Form Title:	ENGINEERING BULLETIN	Document #: EB-01-16 <small>(Form: DEF-003A-1)</small>
			Revision: 1
	Document Title:	Design Change to the Disc and Seal for the External Chemical Hydraulic Valve	Date: March 25, 2020
			Page: 1 of 1

Description of Bulletin: This bulletin provides details concerning a design change to the disc for the external chemical hydraulic valves (CH46955SST, CH46949SST, et. al.). It also provides instructions concerning rebuilds and seal kits.

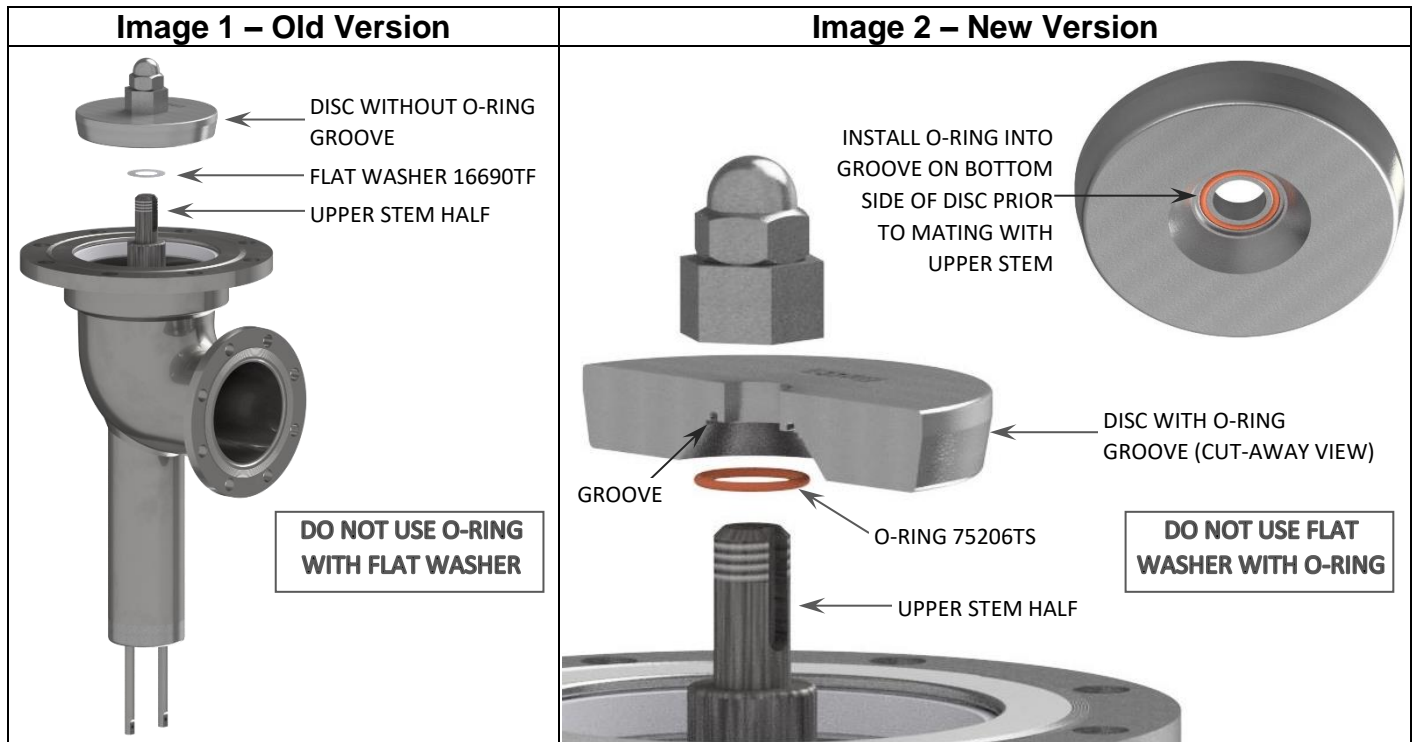
Background/Details: Valves produced prior to February 1, 2016 utilized a flat PTFE washer (16690TF) to seal the joint between the disc and upper stem half. (See image 1.) A design change has replaced the flat seal washer with a Tef-Sil O-ring (75206TS) installed in a machined groove in the disc. (See image 2.) This change was implemented to create a more effective seal and allow for metal-to-metal contact between the disc and the upper stem half. The metal-to-metal contact allows for consistent and continual tension on the stem shaft to keep the cap nut securely in place.

Bulletin Instructions: 75206TS O-ring is also used as the seal between the piston and piston holder. Rebuild kits will now include a second Tef-Sil O-ring (75206TS) to be used for the joint between the disc and upper stem, as highlighted above. Follow these guidelines for rebuild:

- If the disc has the O-ring groove, use the O-ring and discard the flat washer.
- If the disc does not have the O-ring groove, continue to use the flat washer and discard the extra O-ring.
